NEW ORLEANS TO VENICE, LOUISIANA

# EMPIRE FLOODGATE

PERIODIC INSPECTION REPORT NO. 3

SUBJECT: New Orleans to Venice, Louisiana (Hurricane Protection); Reach B-1 -  
Tropical Bend to Fort Jackson, Empire Floodgate, Periodic Inspection  
Report No. 3, 29 July 1981

NEW ORLEANS TO VENICE, LA.  
HURRICANE PROTECTION REACH B-1  
PERIODIC INSPECTION  
EMPIRE FLOODGATE  
**SETTLEMENT AND REFERENCE MARKS  
DIFFERENTIAL'S MOVEMENT**  
U.S. ARMY ENGINEER DISTRICT, NEW ORLEANS  
CORPS OF ENGINEERS  
FILE NO H-4-27323

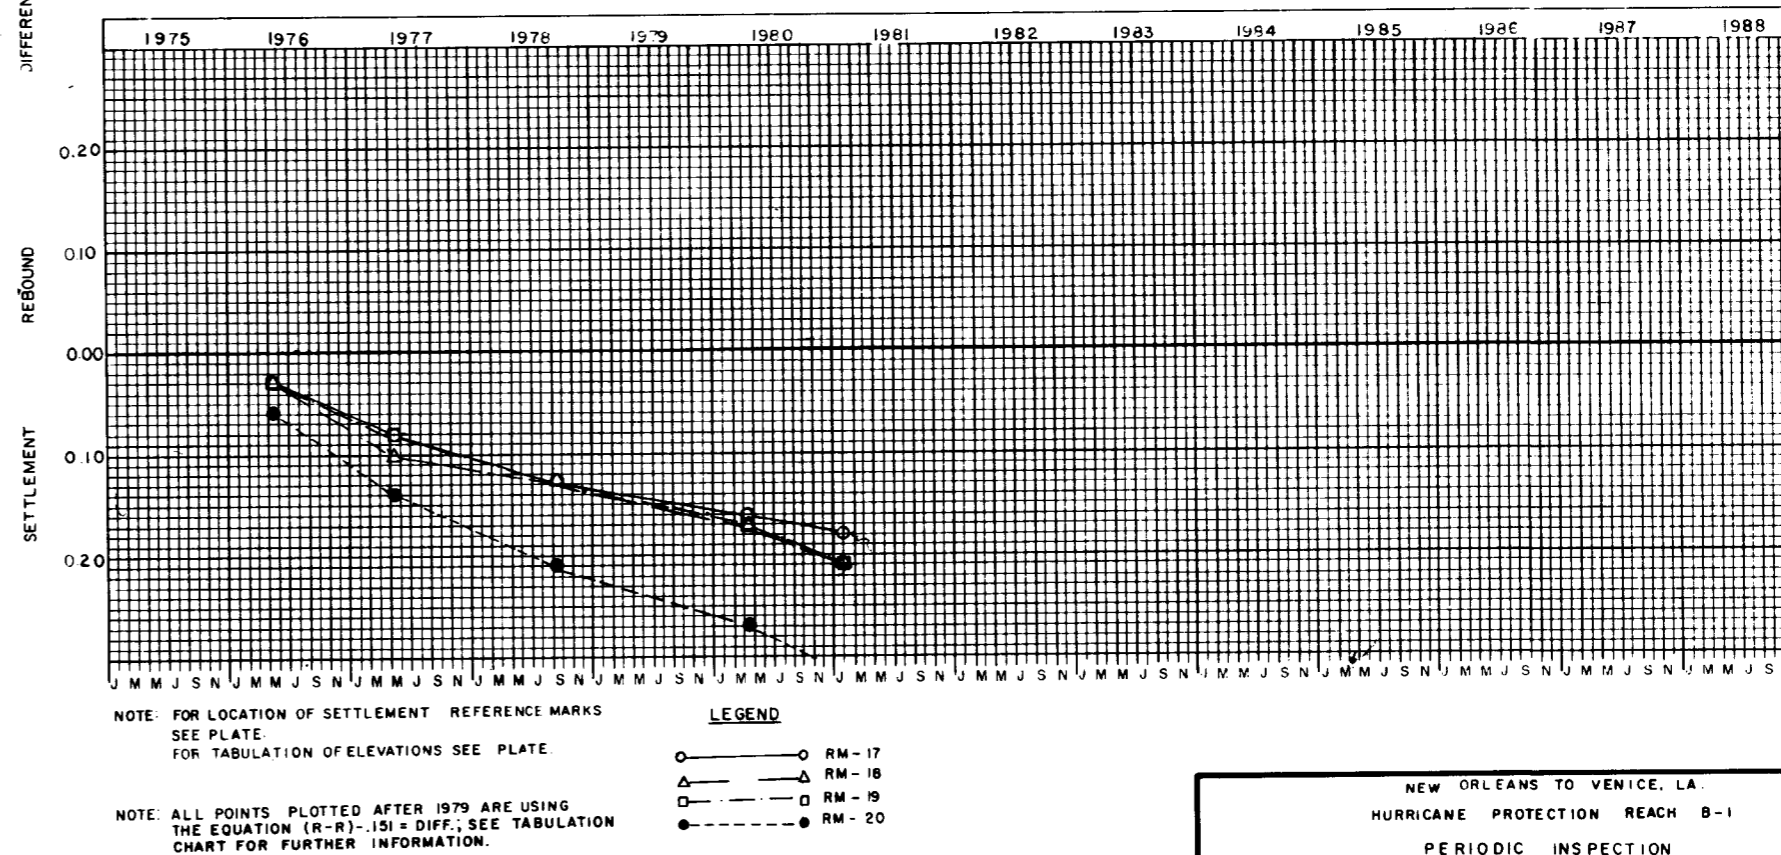
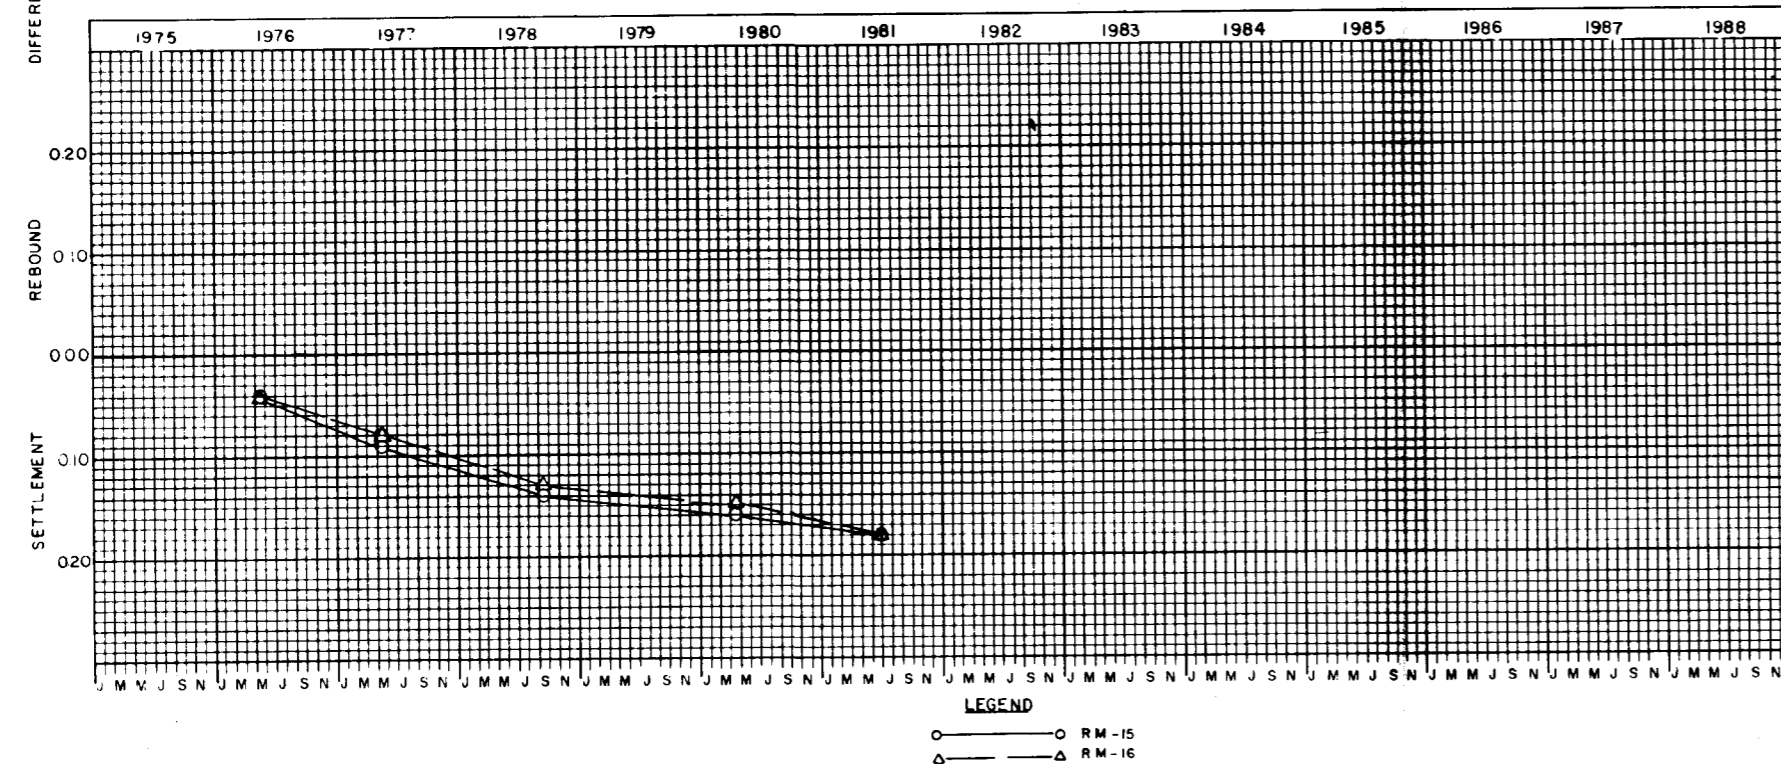
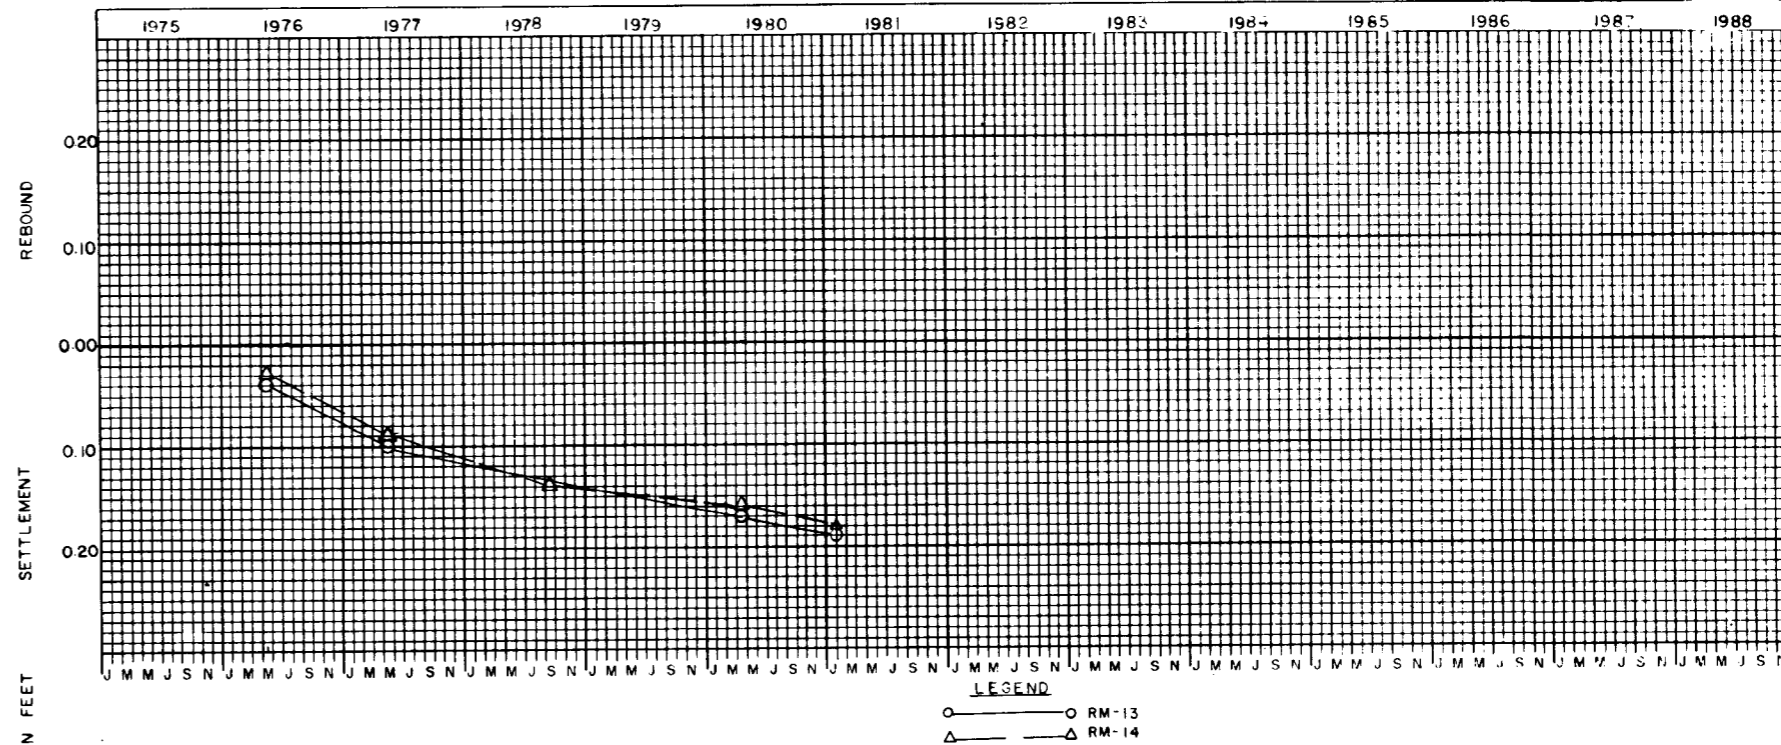
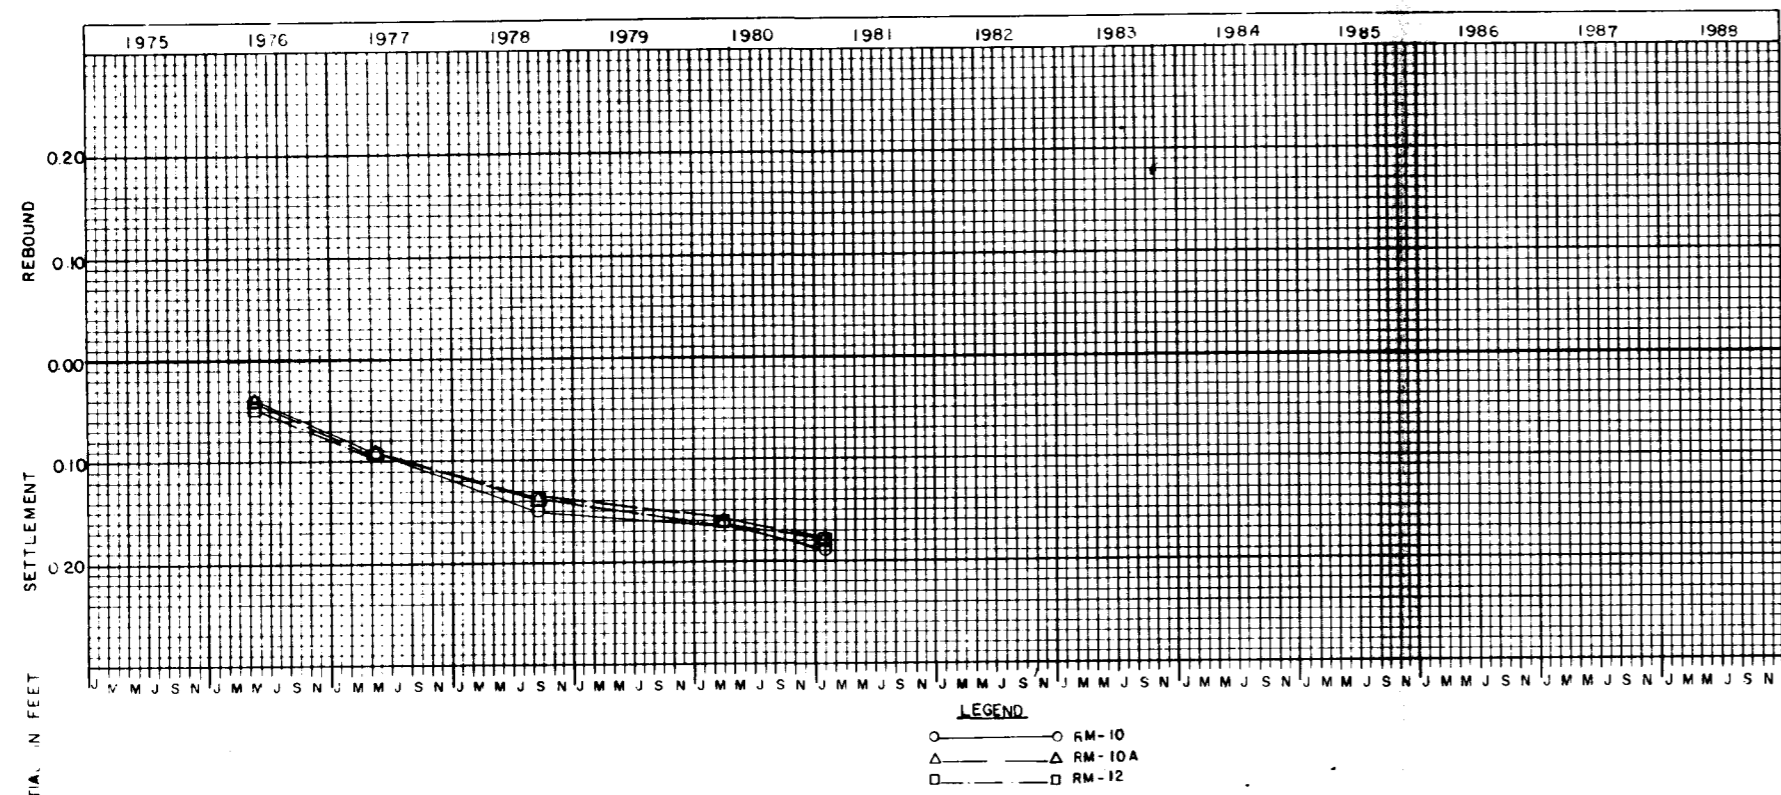
h. Plate I-4. It is noted that no settlement data are plotted for RM-20 in Jan 81. The Jan 81 data for RM-20 in the tabulation "Settlement Reference Marks - Structure and T-wall" on Plate I-2 indicate a rebound of this mark which is not consistent with Jan 81 data for the wall and structure. In view of the significant settlement which has occurred and continues to occur, if not previously accomplished, you should obtain another reading on this point. These data should be presented in your response to this indorsement.

h. Plate I-4. Upon completion of the next scheduled annual survey, data for RM20 will be investigated to determine its consistency with previous data. This is the only method to determine whether the Jan 81 data was a field survey error.

d. Para. h. Although the previous survey was made in Jan 81, the next annual survey was completed on 30 Jun 82. Upon comparing the present settlement data for RM-20 with the reading for Jan 81, it is apparent that the Jan 81 data was a field survey error. The settlement reading for RM-20 on 30 Jun 82 was 14.05 ft. which is consistent with the degree of settlement for previous surveys other than the Jan 81 reading of 14.40 ft.

PLATE 1-6

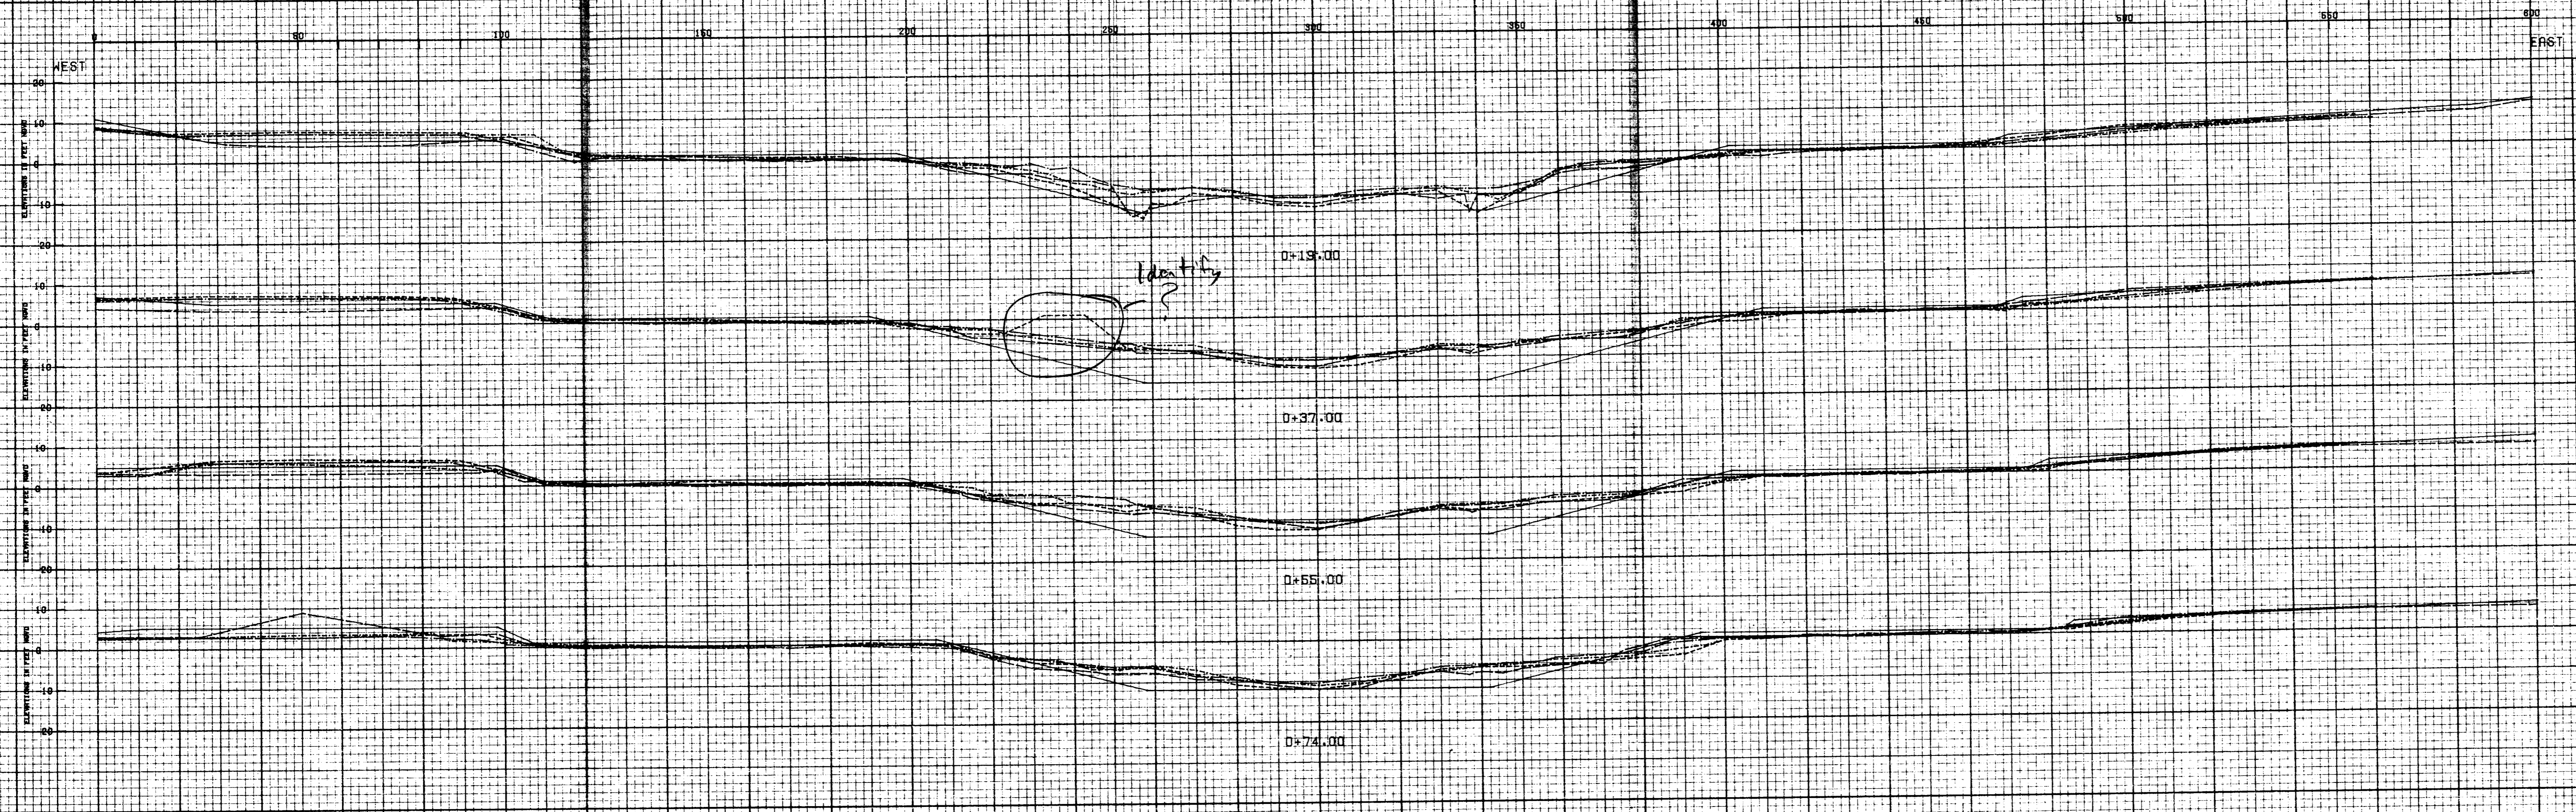
i. Refer to comments in red on Plate I-1, I-3, I-4, I-6, and I-7.

i. Plates I-1, I-3 and I-4 are being revised by drafting personnel. These plates will be issued to your office upon completion. The details noted on Plates I-6 and I-7 are anomalous obstructions picked up during the scour survey. Usually these obstructions are trash on the channel bottom.
